PROJECT	:	Land adjacent Sefter School House, Sefter Road, Pagham
NOTE REF.	:	Acl640/21023/TN
NOTE TITLE	:	Additional Information requested by the LLFA
AUTHOR	:	Tafari Lewis
APPROVED	:	Tafari Lewis
DATE	:	11 th March 2022

This file note has been produced to provide additional information to Arun District Council (ADC) as lead local flood authority (LLFA) on drainage and flood risk for the proposed development of land adjacent Sefter School House, Sefter Road in Pagham.

A Drainage Strategy and SuDS Statement (DS) was produced by Adama Consulting Limited (ACL) in October 2021 (report ref; Acl598/21023/DS Issue 5) which was submitted supplementary to a discharge of conditions application to ADC under reference P/15/22/DOC.

SECTION THROUGH ATTENUATION POND
(SCALE: 1:20)

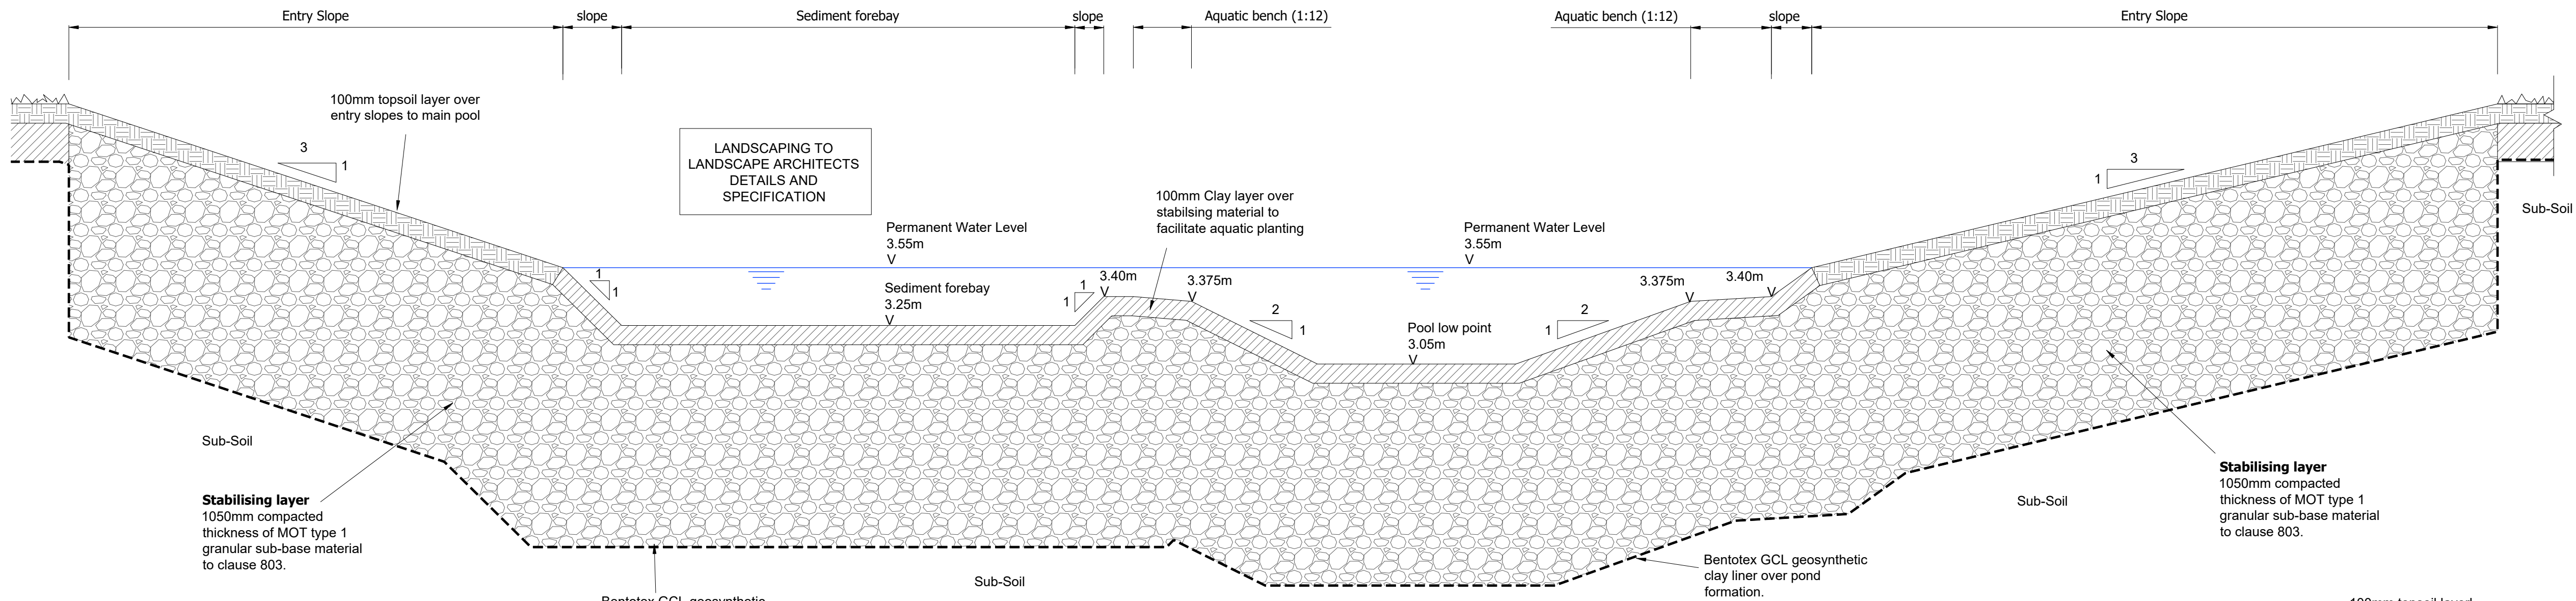
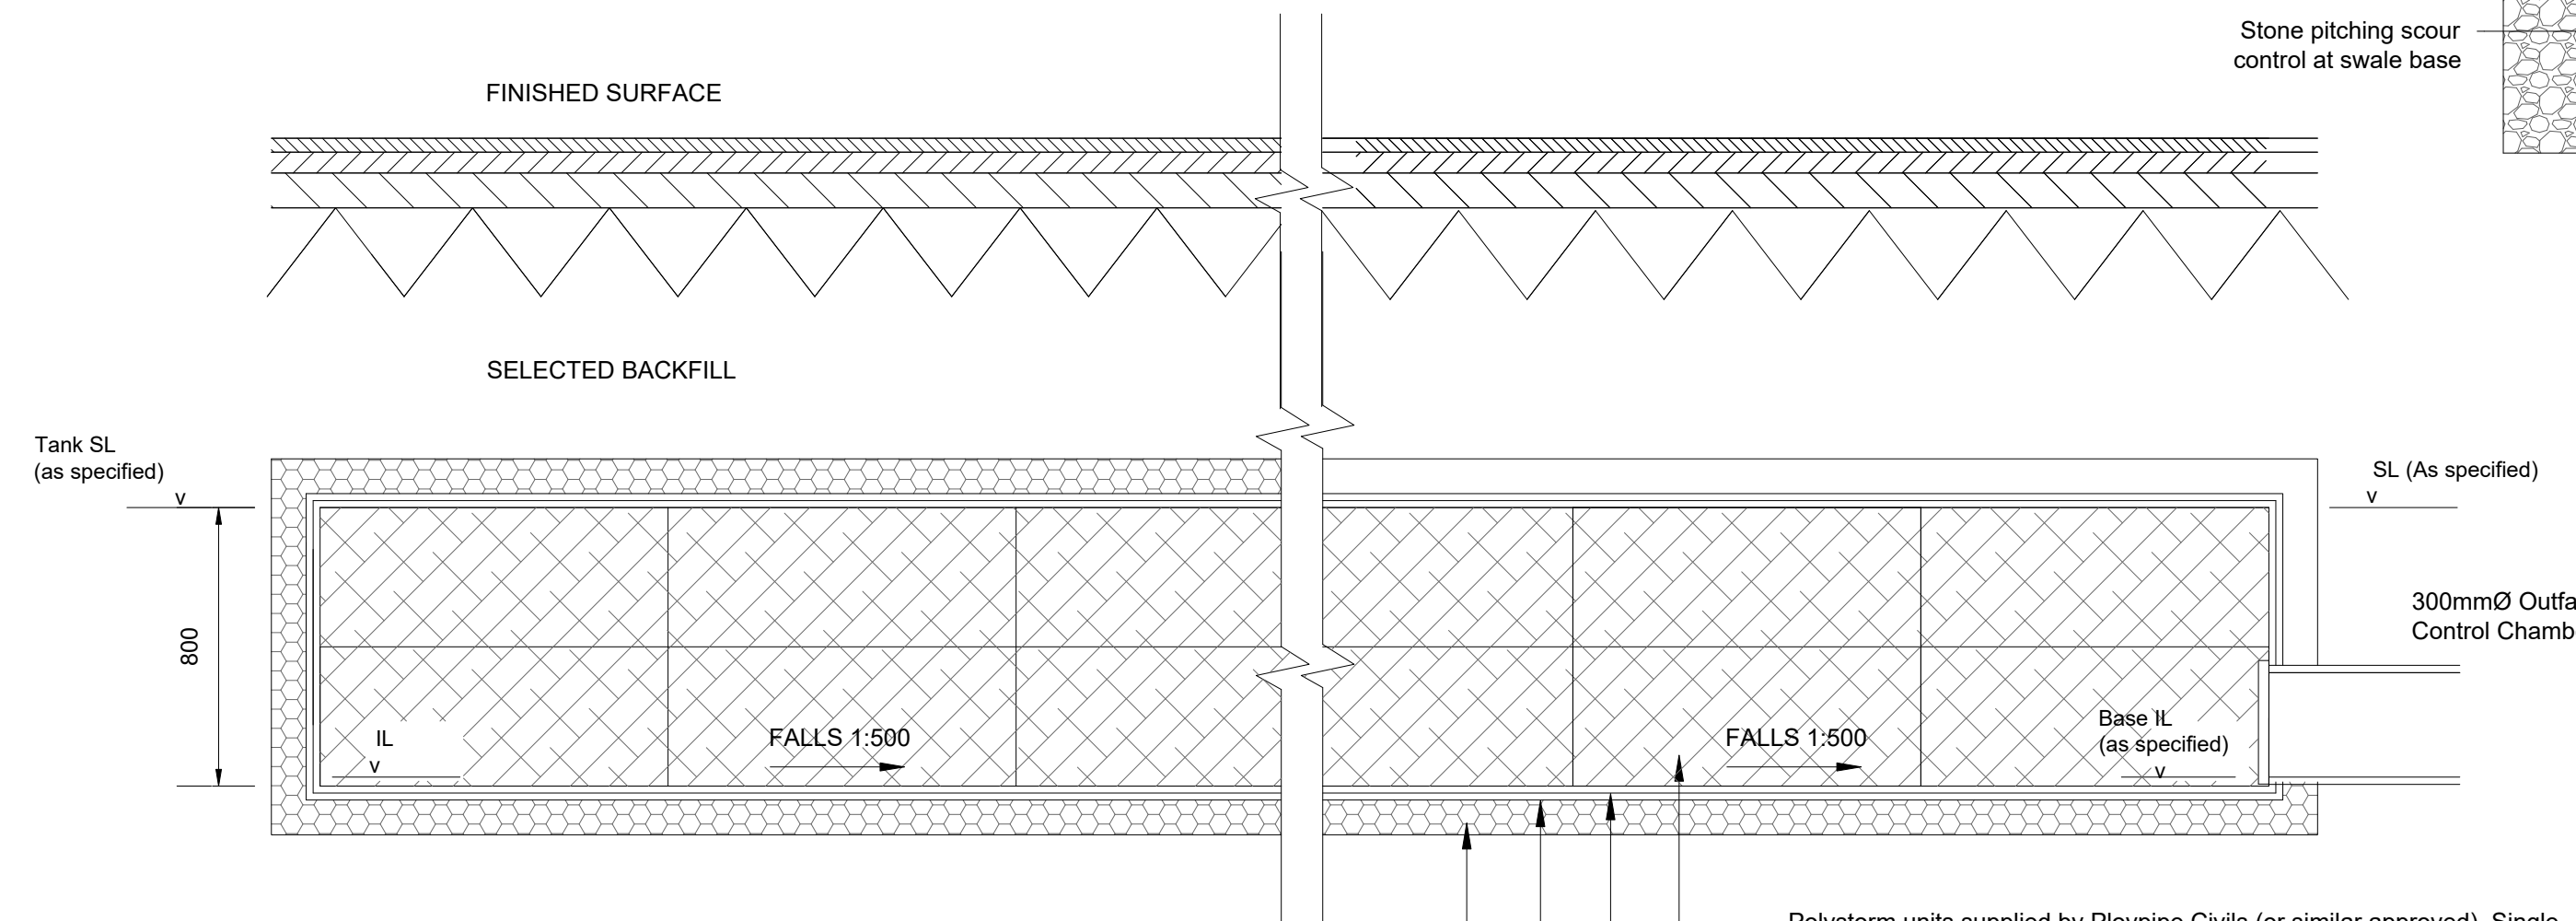
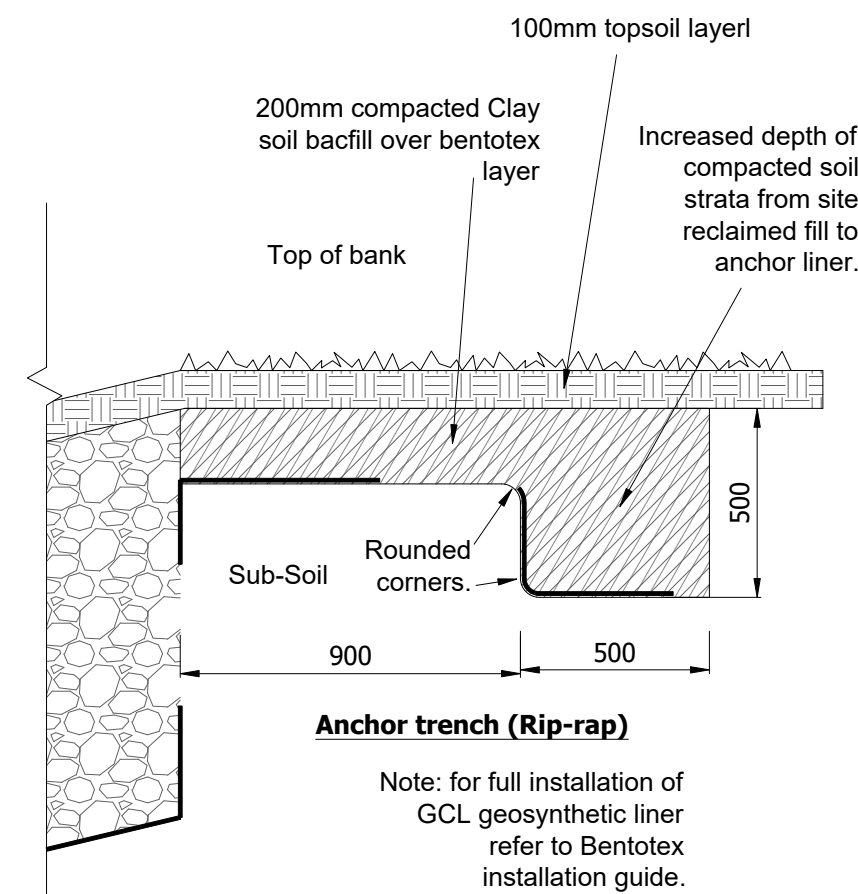
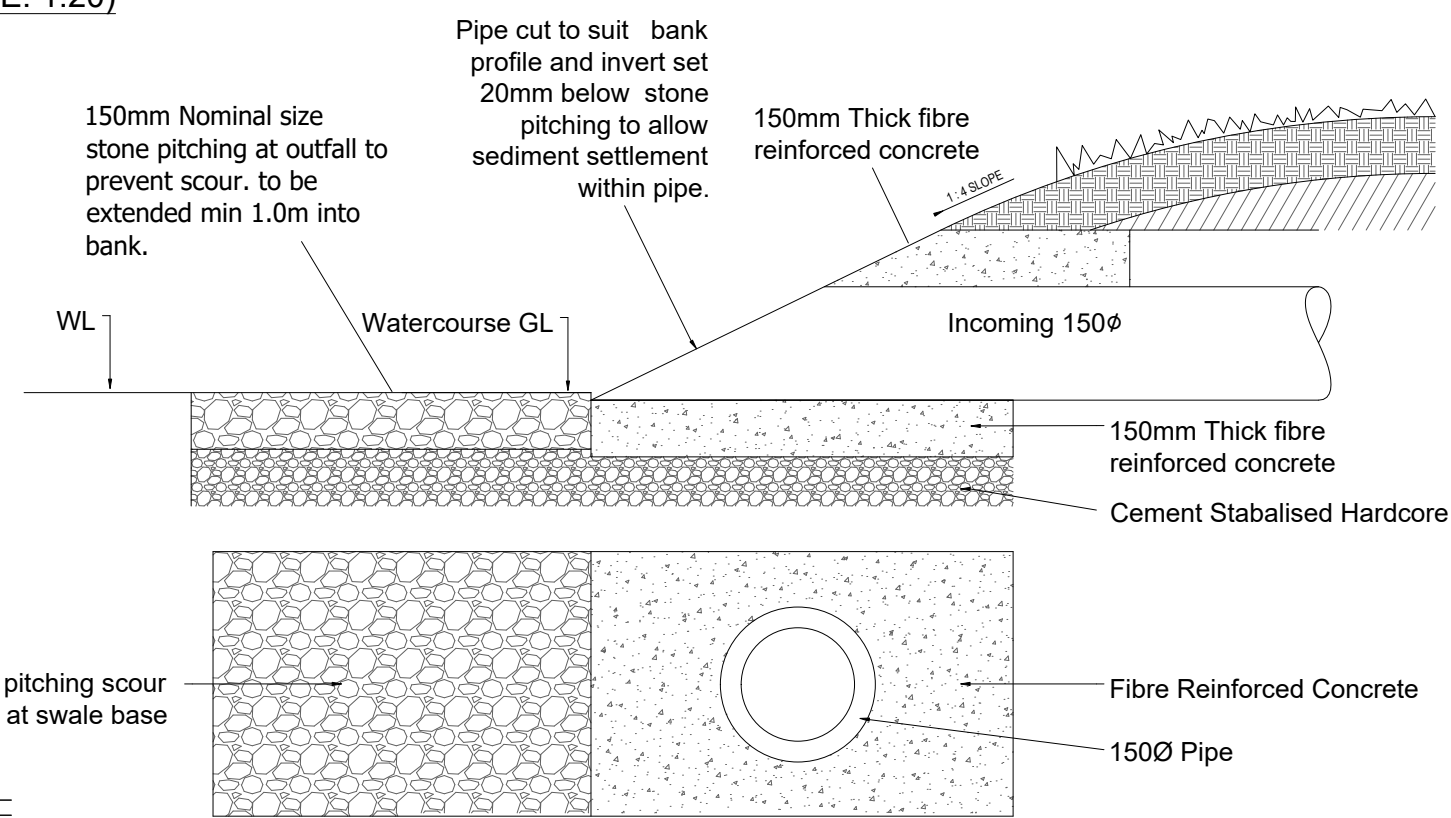
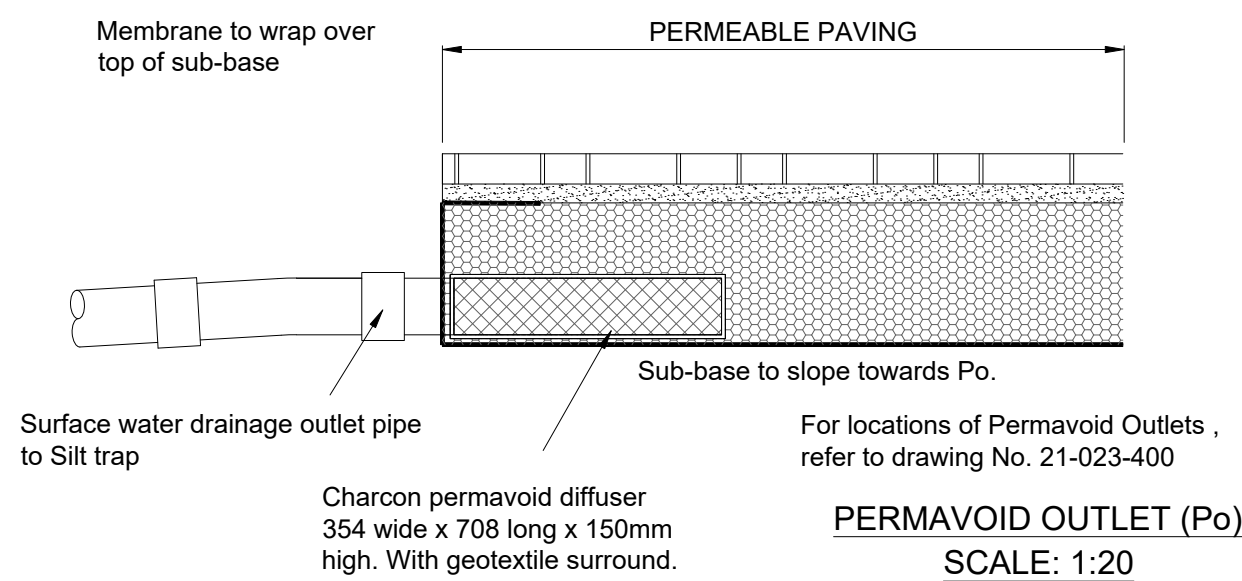
"Please supply site specific construction detail drawings of permeable paving, pipe bed and surround, gullies, manholes, catchpits, attenuation pond (a minimum of two perpendicular cross sections), attenuation tank, headwalls to basin, hydrobrake, outfalls to watercourse, etc."
